Re: Product change notification for Harwin product.

There has been a change to the tape pocket design on the following products:

Old pocket orientation

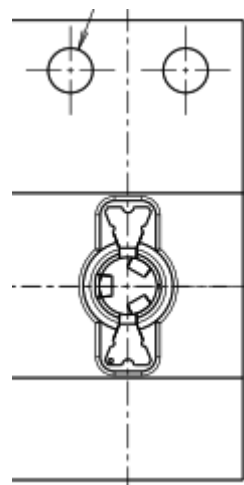
Part Number	Tape Width change	Technical Drawing
S9111-45R	From 12mm to 16mm	https://content.harwin.com/m/2d62dc5e5c4be546/original/DRG-02694-Technical-Drawing-Datasheet-S9111R-pdf.pdf
S9121-45R	From 12mm to 16mm	https://content.harwin.com/m/70cd4d27f5204ee1/original/DRG-02704-Technical-Drawing-Datasheet-S9121R-pdf.pdf
S9131-45R	From 12mm to 16mm	https://content.harwin.com/m/270d1f232a7b6264/original/DRG-02703-Technical-Drawing-Datasheet-S9131R-pdf.pdf
S9141-45R	From 12mm to 16mm	https://content.harwin.com/m/2aea749f5b91459c/original/DRG-02705-Technical-Drawing-Datasheet-S9141R-pdf.pdf

The contacts have changed orientation in the tape:

This revised packaging method has been tested and continues to meet the EIA-481 requirements. The Sycamore Contact sockets are not affected and remain unchanged.

This packaging improvement minimises the risk of these miniature low-profile contacts turning or twisting within the pocket - increasing assembly efficiency.

All new and existing orders at Harwin for S9111-45R product will be supplied in the new tape and reel packaging. Reels with the new orientation pockets will be clearly labelled for a minimum of 12 months. Using the new orientation will require a change to your Pick/Place machine setup.
